PRODUCT / PROCESS CHANGE NOTIFICATION

1.1 Company	 STMicroelectronics International N.V
1.2 PCN No.	MDG/23/14078
1.3 Title of PCN	STM32H503RBT6 - product enhancement
1.4 Product Category	STM32H503RBT6
1.5 Issue date	2023-05-16

**PRODUCT/PROCESS
CHANGE NOTIFICATION
PCN14078 – Additional information**

STM32H503RBT6- product enhancement

Example: Marking on package LQFP 100 14x14x1.4

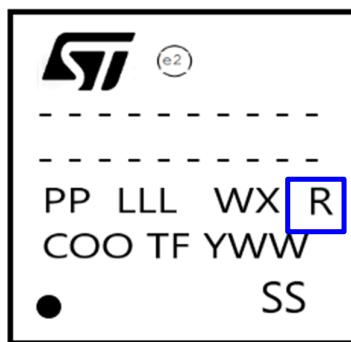
Current condition	New condition
Front-End Diffusion site	ST Crolles 300 (France)	
STM32H503RBT6	Cut 1.1	Cut 1.2
Die revision Marking R	“Z”	“Y”
